ADDENDUM NO. 2

May 6, 2022

NEW ADMINISTRATION CENTER, ALTERNATE EDUCATION AND RESOURCE CENTER AND RELATED WORK PROJECT
Crown Point, IN 46307

ADDENDUM TWO

NEW ADMINISTRATION
REFER TO SHEETS:
G-201
A-101
A-102

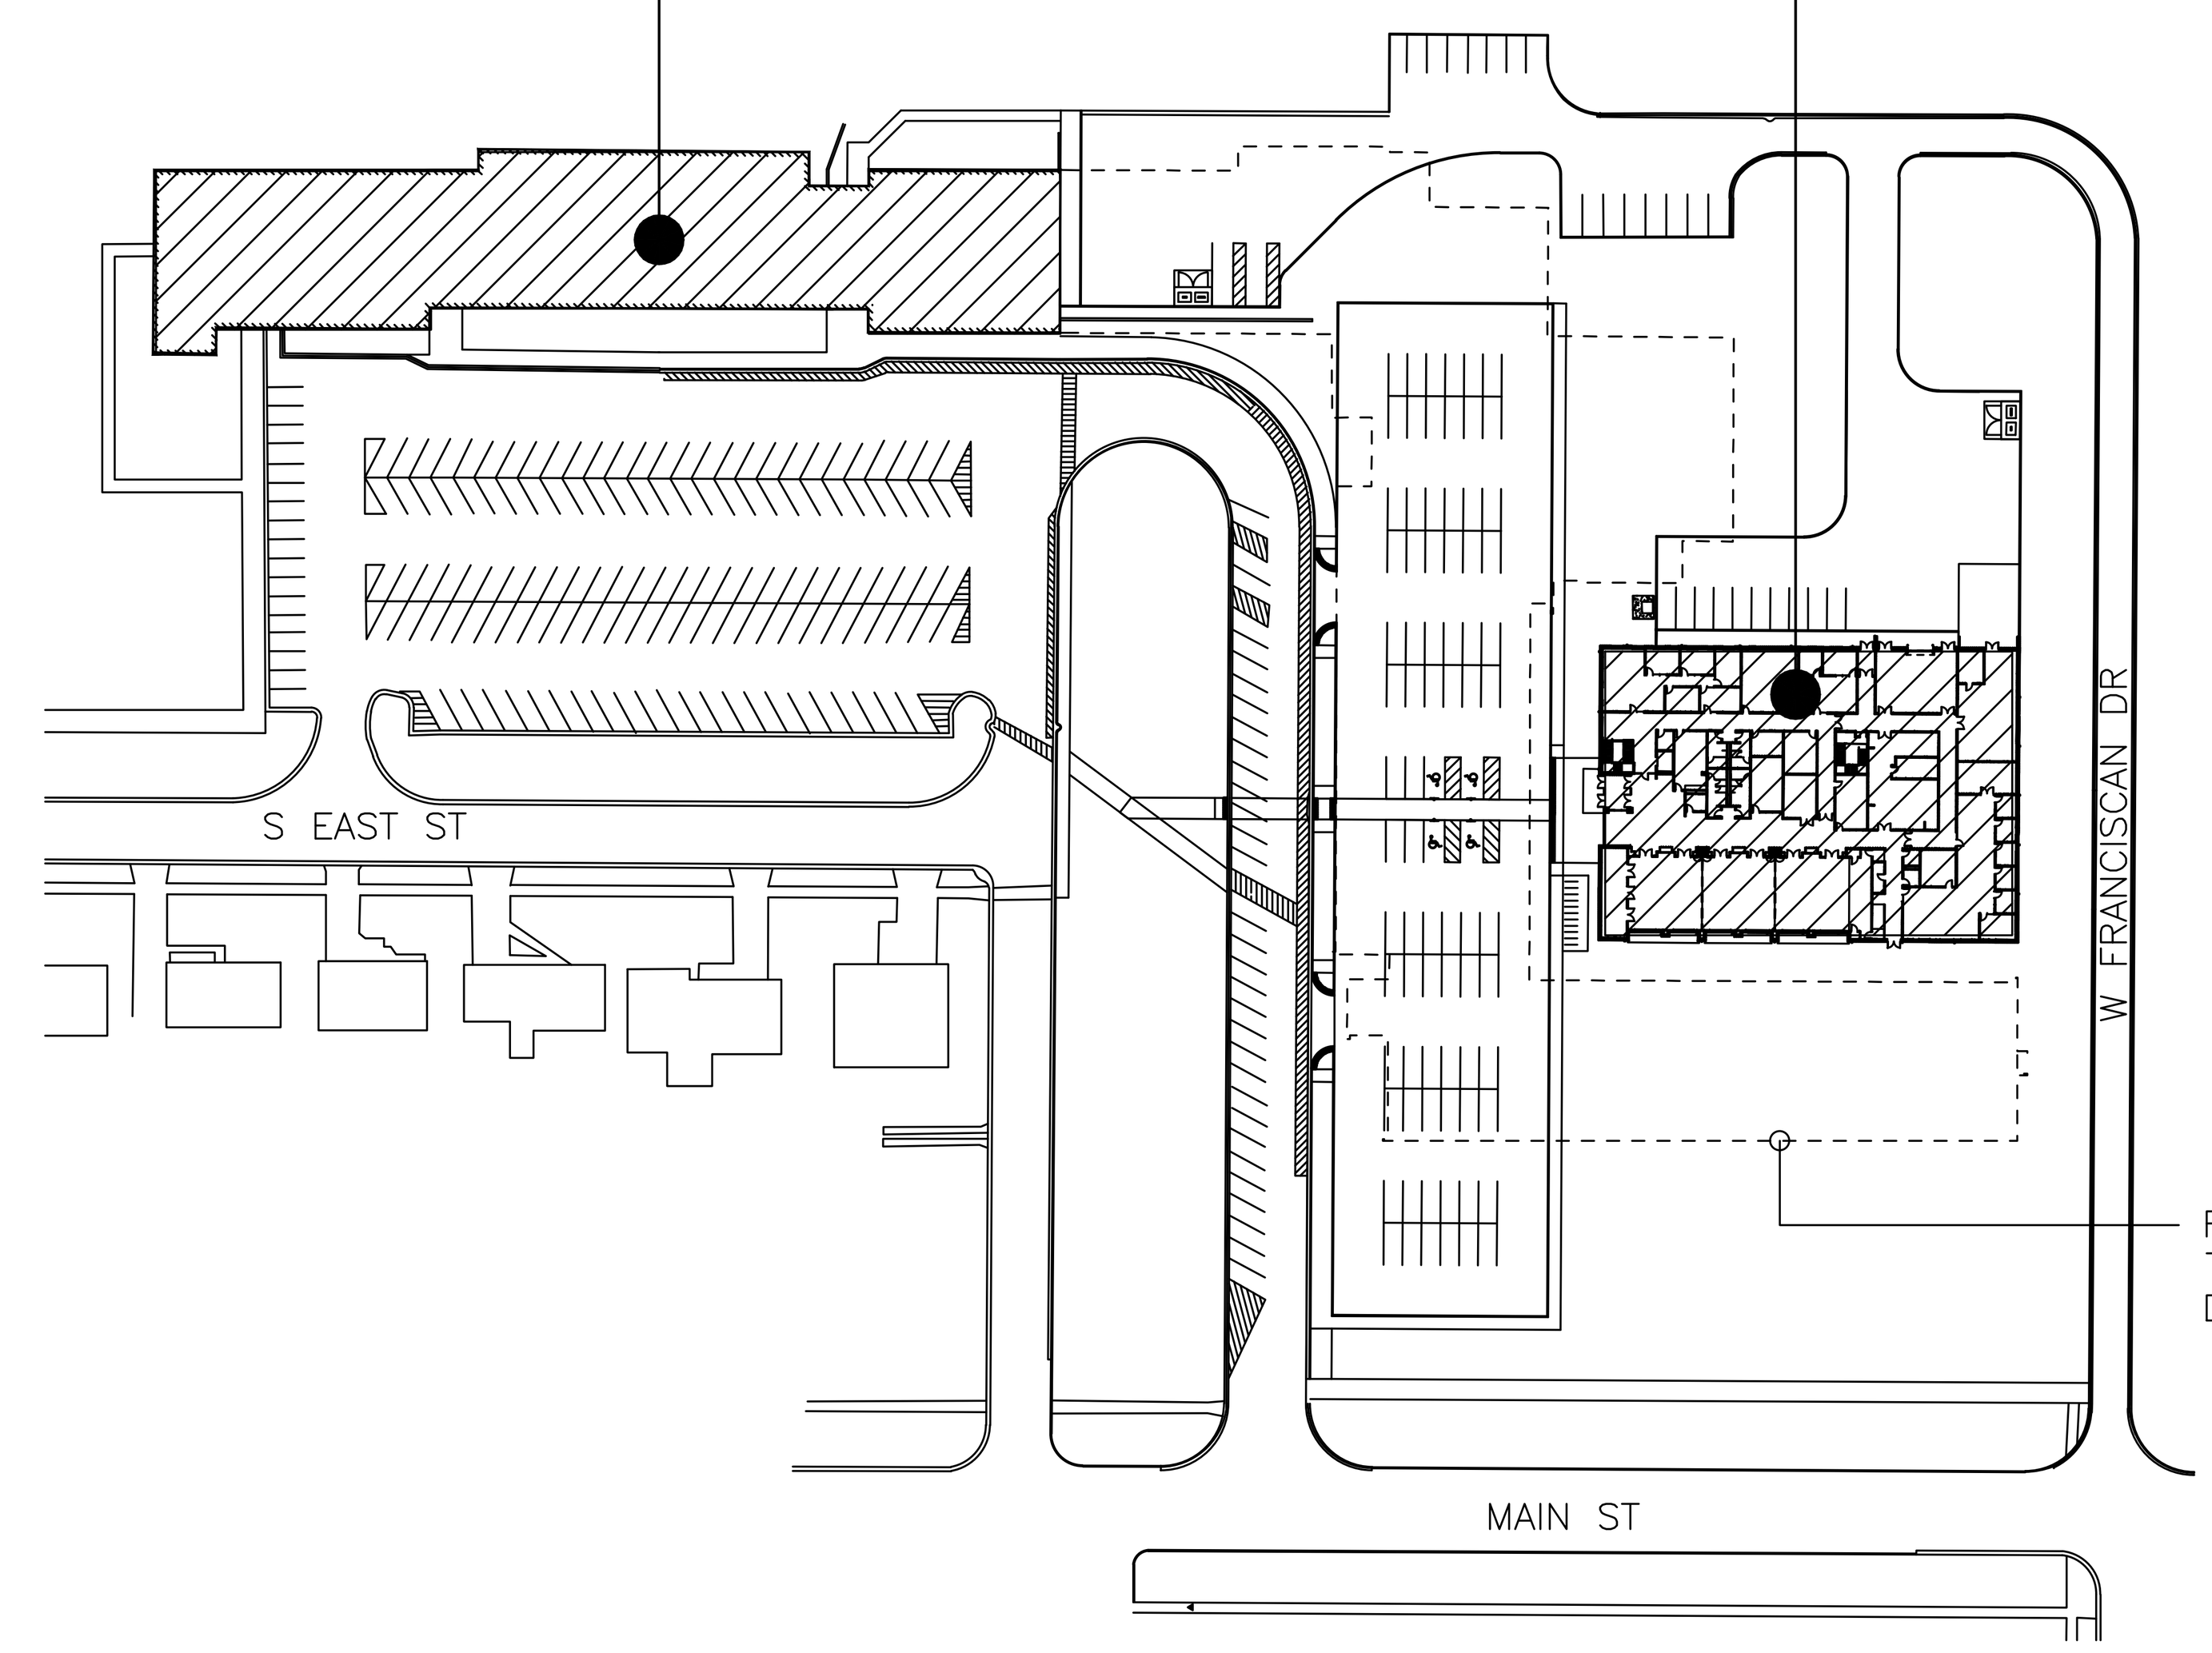
1. Added a site map to highlight the relationship between the locations of the Administration Building and the Alternate Education Building.

GIBRALTAR DESIGN
SHEET
AD C-101

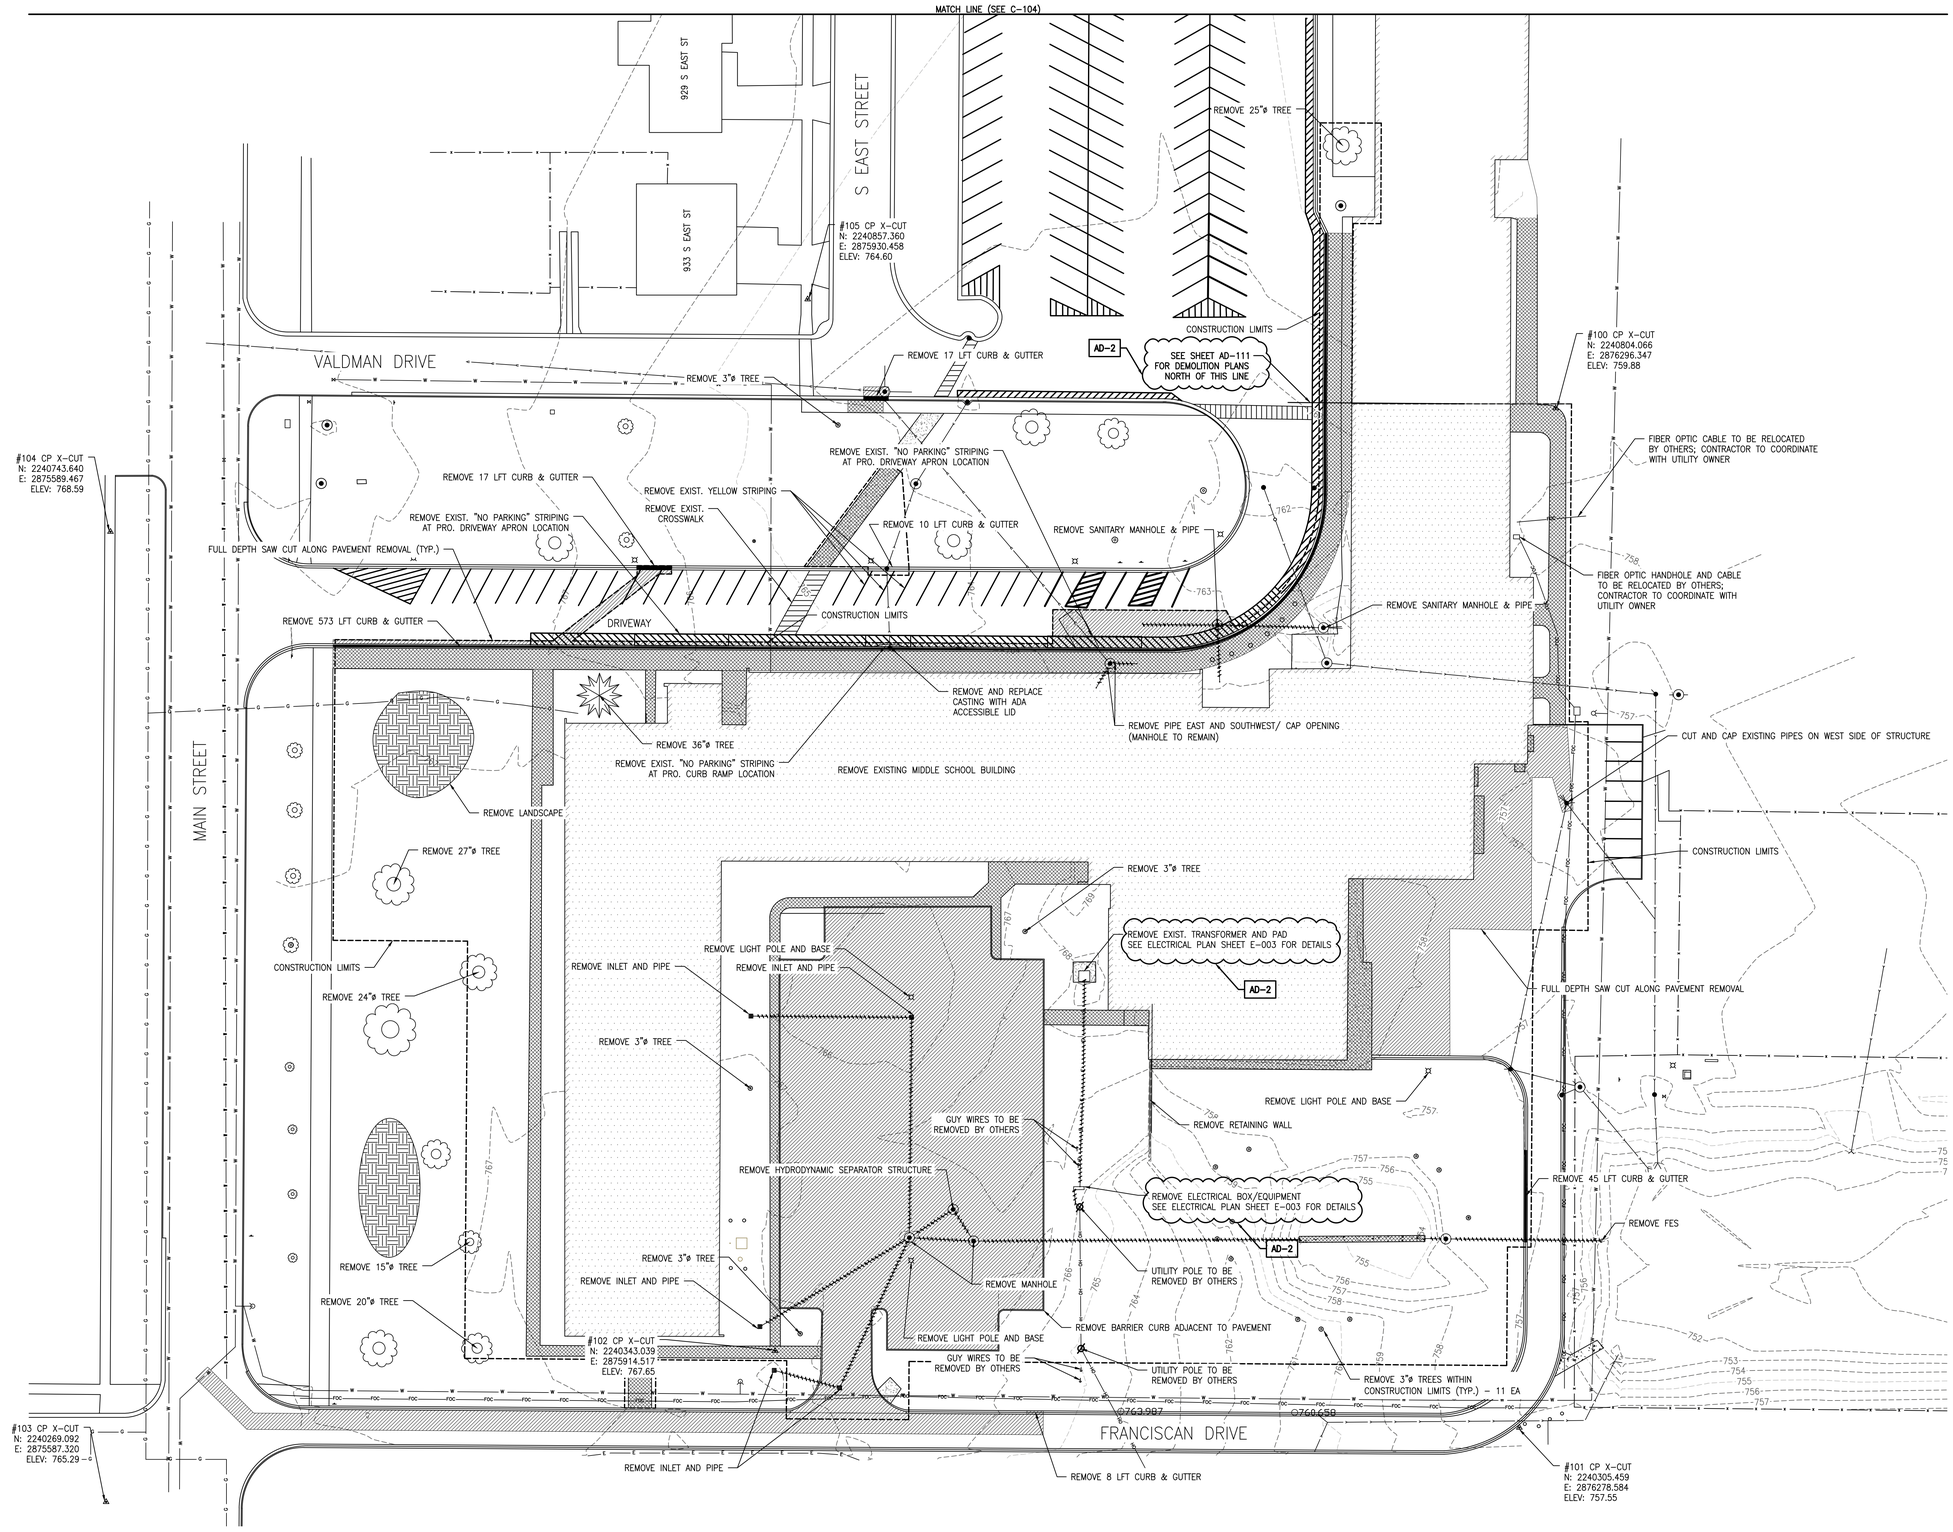
1. Added reference to Electrical Sheet E-003 for electrical wiring and demolition details.
2. Added reference to Sheet AD-111 for sidewalk demolition north of shown match line.
3. Removed contours passing through existing building footprint.

1. ADDED REFERENCE TO ELECTRICAL SHEET E-003 FOR ELECTRICAL WIRING AND DEMOLITION DETAILS.
2. ADDED REFERENCE TO SHEET AD-111 FOR SIDEWALK DEMOLITION NORTH OF SHOWN MATCH LINE.
3. REMOVED CONTOURS WITHIN EXISTING BUILDING FOOTPRINT.

SHEET
AD C-105

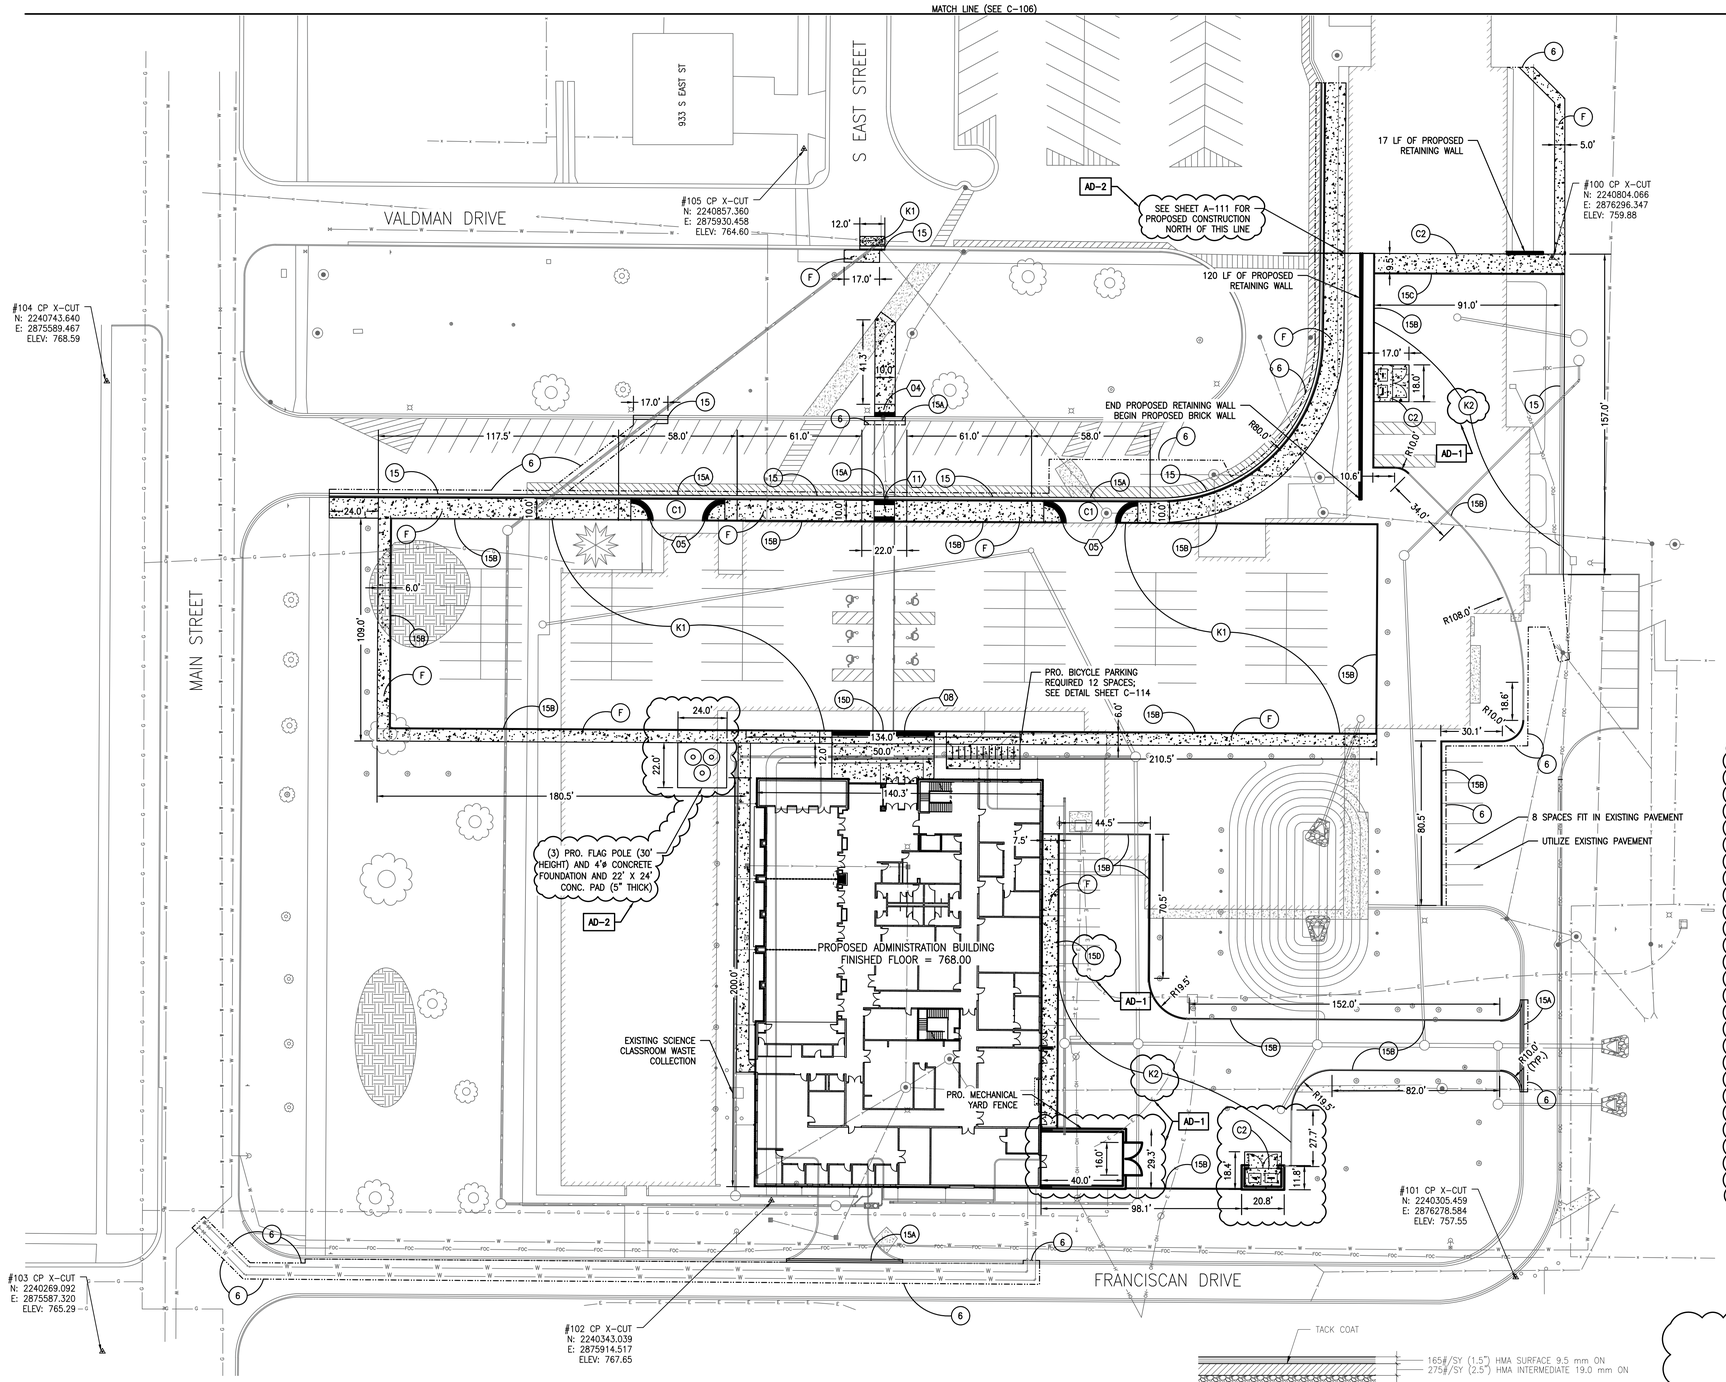
1. Added callout o proposed sidewalk referring to Sheet A-111 for detailed construction notes north of shown match line.
2. Added flag pole foundation detail.
3. Added flag pole callouts.
4. Added Note 13 with flag pole information.

AD-2 REVISIONS:
1. ADDED CALLOUT ON PROPOSED SIDEWALK REFERRING TO SHEET A-111 FOR DETAILED CONSTRUCTION NOTES NORTH OF SHOWN MATCH LINE.
2. ADDED FLAG POLE FOUNDATION DETAIL.
3. ADDED FLAG POLE CALLOUTS TO PLAN SHEET.
4. ADDED NOTE 13.
